Appendix H

Conceptual Engineering Analysis

Conceptual Engineering Analysis of Expressway and Viaduct Options

OVERVIEW OF
MAINTENANCE CONCERNS
FOR

Exhibit H-4

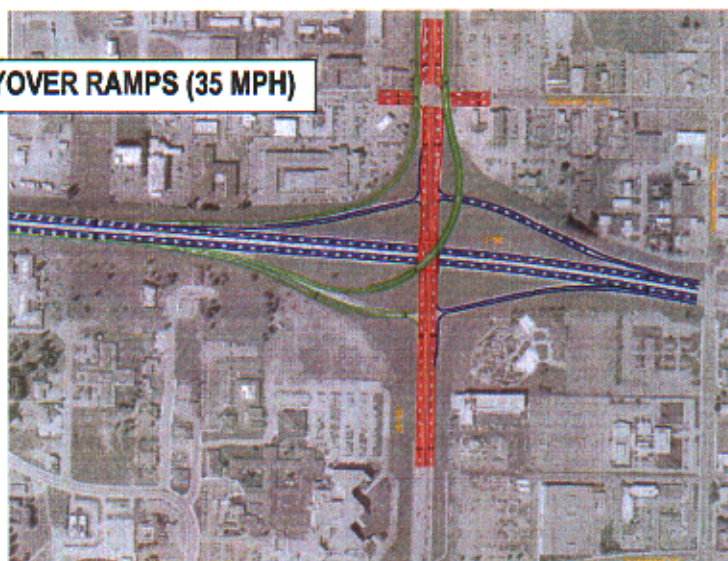
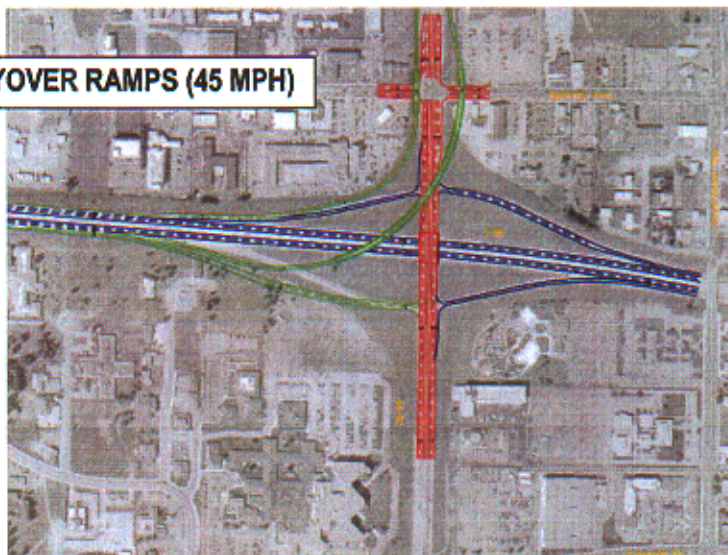
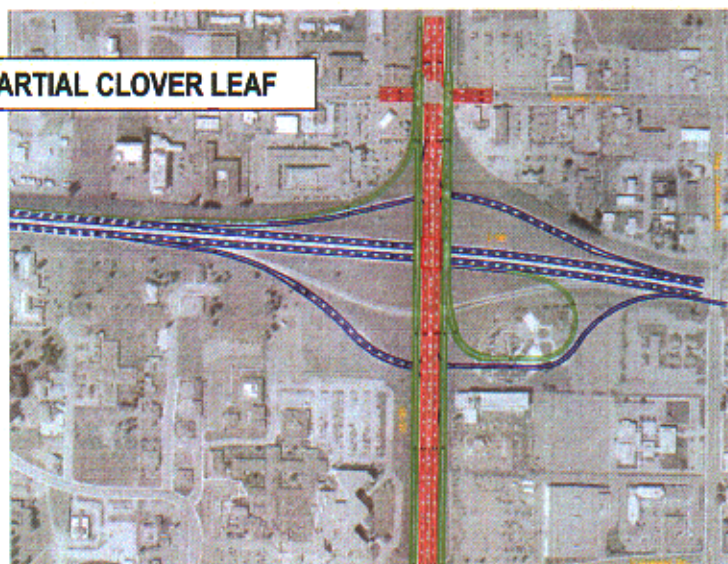
- **Winter maintenance:** The existing diamond interchange is the easiest configuration to provide snow and ice control. Even though vehicles must pass through traffic signals, there are options available for continuing snow and ice control work, i.e., a plow truck approaching from I-90 eastbound has the option of returning west, going north or south, or continuing across the crossroad and returning to I-90 eastbound.
With the Alternative 3 options, there are no routing alternatives once the plow truck enters the ramp; the options of continuing easterly, southerly or returning to I-90 westbound are not available without considerable out-of-direction travel.
The elevated structure will require more time and care to clear snow and ice because of the adverse combined effect of roadway grade and superelevation. Effective grades near 7 percent (superelevation and profile grade) will be required between ramp lane convergence points and the vertical clearance points over US 95. This grade is excessive for slow moving vehicles such as snowplows; the vehicle has a tendency to slide to the low side of the super. If such a vehicle has to stop on the grade, it is nearly impossible to start up again without mechanical aids such as chains. This might be a site to consider the use of an automatic anti-icing system.

ALTERNATIVE 3b: MODIFIED CLOVERLEAF RAMP: There are two possibilities for this modification. (1) The first would gain about 22 feet to tie to the shoulder elevation of existing US 95. (2) The second would need to rise over 40 feet to meet the shoulder elevation of a US 95 viaduct. Either could be done at 3 percent or less grades.

Grades for the fly-over ramps or the modified cloverleaf ramp should be minimized.

**INTERCHANGE CONFIGURATION
FOR REVISED RIGHT IN - RIGHT
OUT TRAFFIC CONTROL**

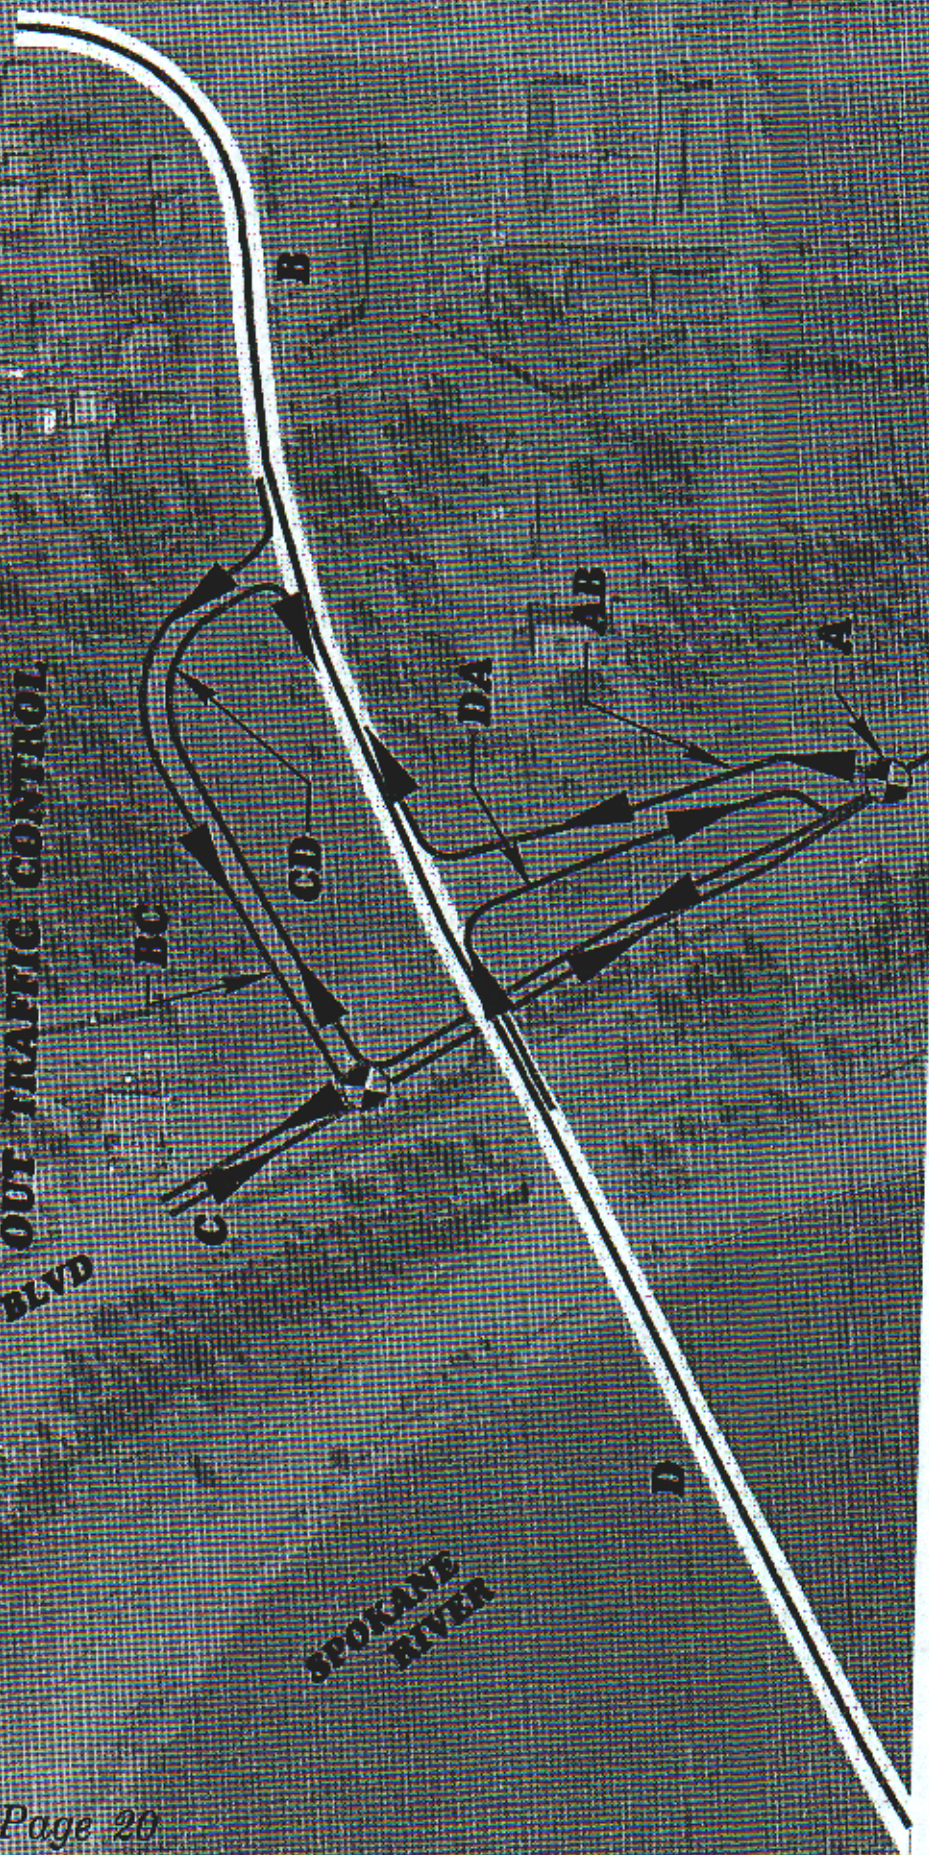
SIGNING: Signing for side by side ramps such as A -- AB and BC --CD is difficult. Motorists do not expect this configuration, so preventing wrong-way moves will be a problem. A conventional 4-way intersection would be easier to sign and maintain.

The right in – right out concept could be developed for the existing DA and AB ramps to provide a conventional 4-way, signalized intersection with Northwest Boulevard. This would provide motorists with a more familiar intersection than trying to sign and delineate side by side DA and AB ramps. Right of way would be required from Coeur d'Alene Homes for any configuration to provide turning roadways to an intersection rather than the present slip ramp entrance.

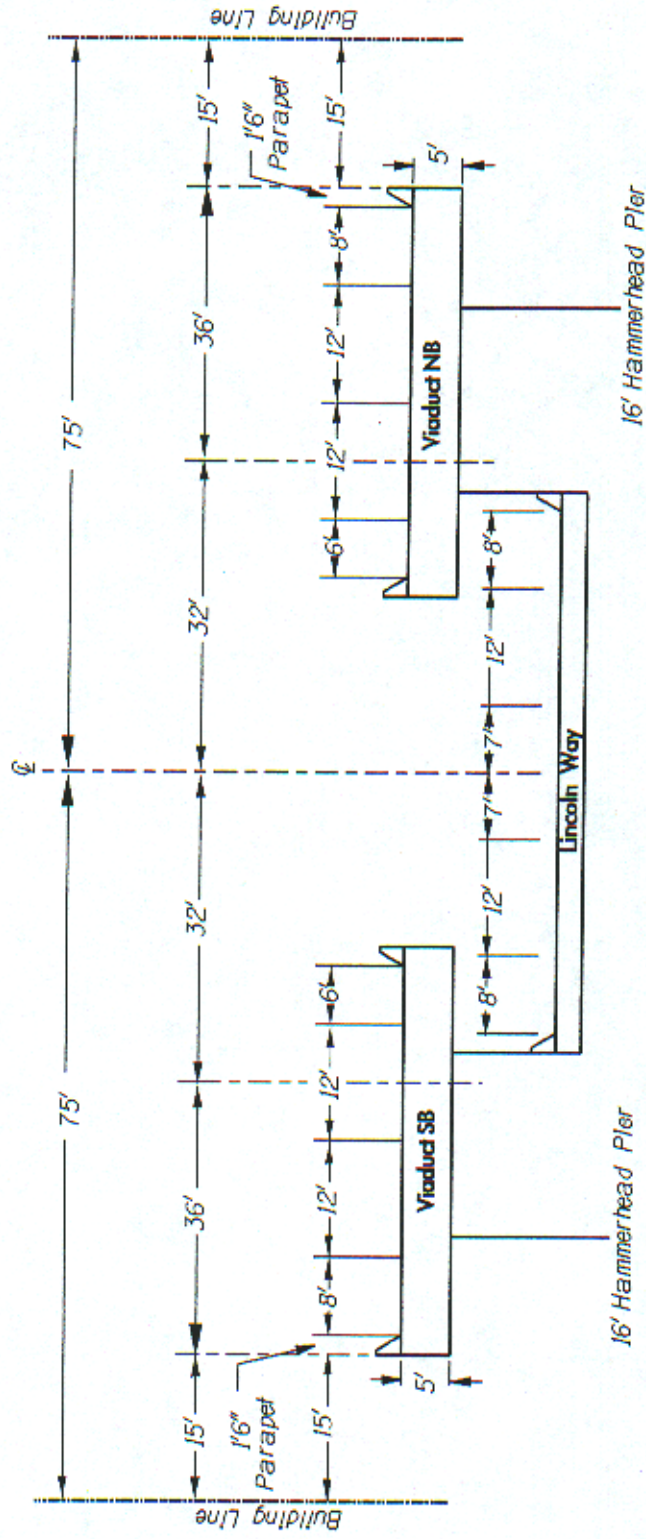
➤ If this alternative would be selected for further development, consideration should be given to spreading the viaduct structures laterally to remove any overhang over Lincoln Way. This would increase the right of way required to about 140 feet but there would not be much additional impact on the businesses abutting Lincoln Way

If a sidewalk were constructed at the right of way line, there would be concern about snowplowing operations throwing snow and ice on pedestrians below. Even the best of operators, under the best of conditions, sometimes cannot anticipate road conditions; a large chunk of ice flying at 25-30 mph would do extensive damage to adjacent buildings or to pedestrians.

District maintenance personnel expressed the opinion that they would be required to use a motor grader to remove snow and ice. This is a low-speed vehicle that would be able to move snow and ice across the pavement without "lifting" it and throwing it over the side. Snow would then have to be loaded and hauled from the structure. Normally, the motor grader would not be the vehicle of choice for snow and ice control, since it is slower than a truck plow and presents a greater accident potential for conflicts with traffic.

Noise created by vehicles on the viaduct structure would be significant. Noise barriers high enough to intercept sound from these vehicles would not be feasible. Ongoing complaints about noise could be expected. Particular attention should be paid to expansion joint design – self cleaning for antiskid material and to minimize impact noise.
